Final Product/Process Change Notification

Document #: FPCN24928Z

Title of Change:	Schottky Metallization Change And Lead Frame Modification for SOD 123 FL Package.
Proposed Changed Material First Ship Date:	01 Feb 2024 or earlier if approved by customer
Current Material Last Order Date:	N/A <i>Orders received after the Current Material Last Order Date expiration are to be considered as orders for new changed material as described in this PCN. Orders for current (unchanged) material after this date will be per mutual agreement and current material inventory availability.</i>
Current Material Last Delivery Date:	N/A <i>The Current Material Last Delivery Date may be subject to change based on build and depletion of the current (unchanged) material inventory</i>
Product Category:	Active components – Discrete components
Contact information:	Contact your local onsemi Sales Office or SitiNurhaza.MohdRamli@onsemi.com
PCN Samples Contact:	Contact your local onsemi Sales Office to place sample order. Sample requests are to be submitted no later than 45 days after publication of this change notification. Samples delivery timing will be subject to request date, sample quantity and special cu

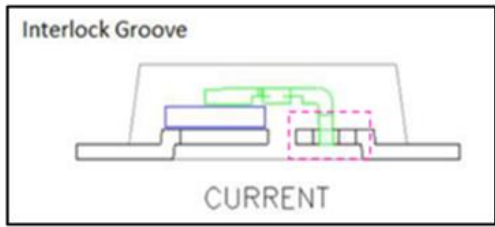
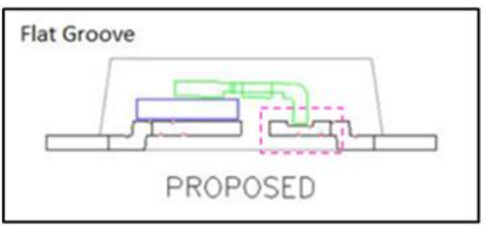
From	To
Top metalization	TiW/NiV/Au	TiW/NiV/Ag
Back Metalization	Cr/Ni/Au	Ti/Ni/Ag
Leadframe
